ENCLOSURE 1  
YANKEE ROWE  
AUXILIARY FEEDWATER SYSTEM

X.17.2 Reliability Evaluation Results

Recommendations for this Plant

## ENCLOSURE 2

Auxiliary Feedwater System  
 Yankee Rowe  
 Figure 1

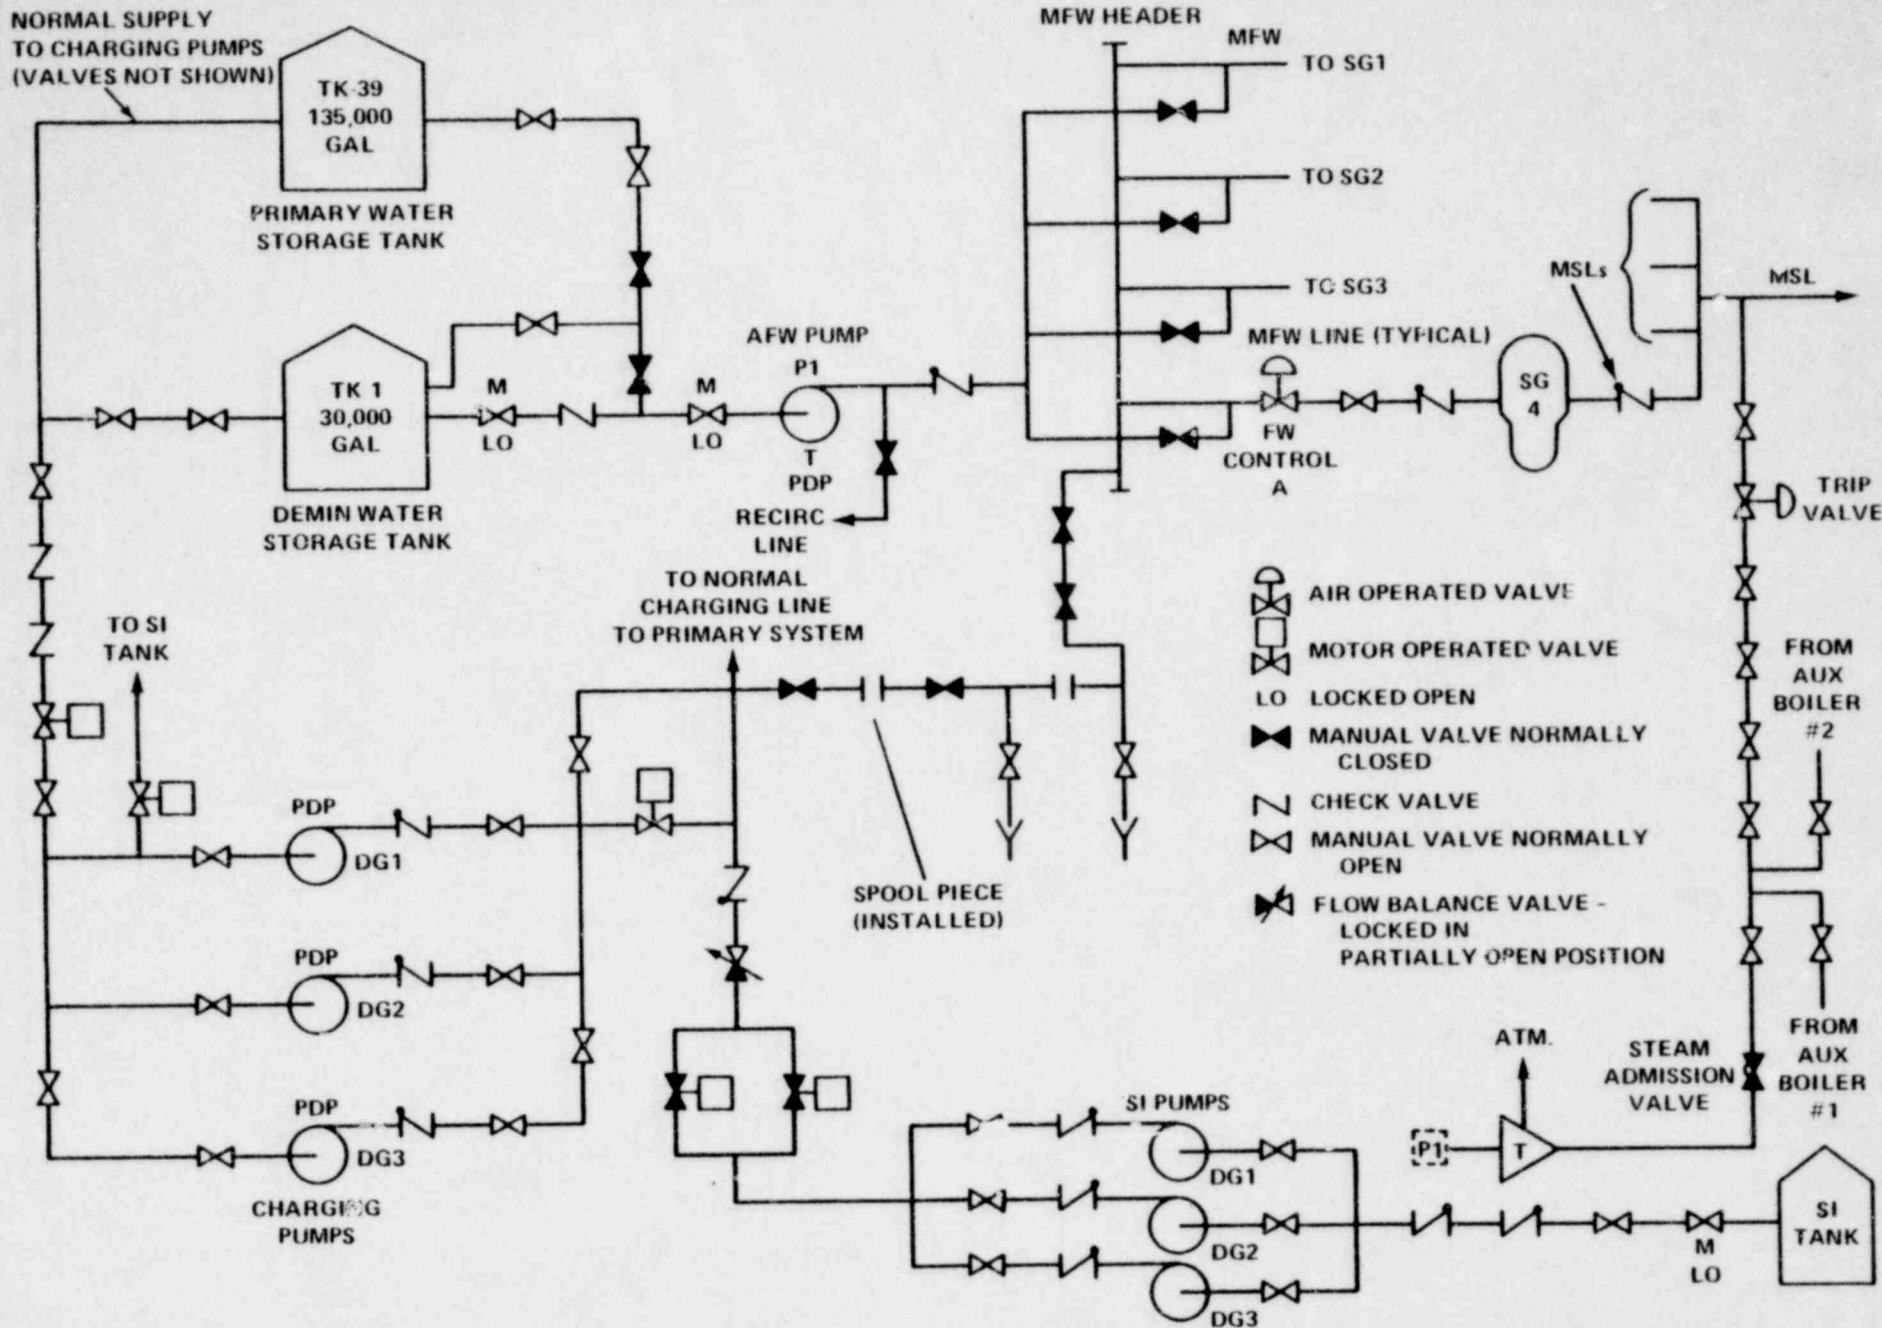
2. Recommendation - Initiation of AFW flow (including flow from the backup systems-charging/SI) to the steam generators requires several local manual operator actions outside the control room. Even though there is a reasonable time period (up to one hour before the S/G's will boil dry) for operator action and a dedicated operator, the licensee should improve the reliability of initiating AFW flow by providing the capability to start the pumps and open the valves of the AFWS by operator action from the control room. Local manual operation capability should be retained as a backup to remote manual operation capability.

3. Recommendation - A pipe break in the Main Feedwater header upstream of the control valves could cause loss of all AFW flow to all steam generators since the AFW pump and the charging/SI pumps connect to this header. The licensee should evaluate the consequences of a pipe break in this section of the MFW header and 1) determine any system design changes or emergency procedures necessary to detect and isolate the break and direct the required AFW flow to the steam generators before they boil dry or 2) describe how the plant can be brought to a safe shutdown condition by use of other available systems following such a postulated event.

4. Recommendation - The air operated trip valve in the auxiliary steam header which supplies steam to the turbine driven AFW pump closes upon receipt of a containment isolation signal. The

licensee should review the design basis for this circuit logic to determine whether all events that can generate a containment isolation signal should in fact, shutdown the AFWS. As a result of this review, describe any design changes or procedure changes that will be proposed to assure AFW system and containment isolation capability.
